SUNNINGDALE PARISH COUNCIL

**20/01765 - T1 - 2 Hamilton Drive Sunningdale Ascot SL5 9PP
Oak. Crown Thinning by 30%, T2 - Conifer - fell. (TPO 2 of 1964)**

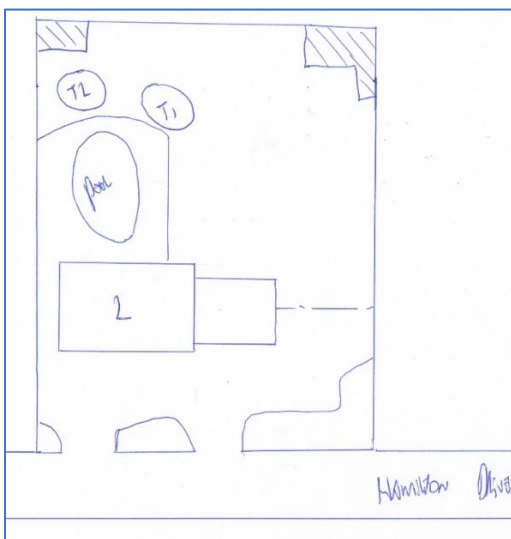
Firstly, whilst T1 is stated as an oak tree the applicant has now specified that T2 is a conifer. This requires some clarification as it was originally an oak tree, revised to a sweet chestnut by RBWM and now it is a conifer. Also, T1 and T2 on the previous application are now transposed on the current application as can be seen in the drawings below:

Apart from these discrepancies of tree position and description, the Parish Council find it hard to reconcile the RBWM stated reasons for refusal of 19/03347 with the current application.
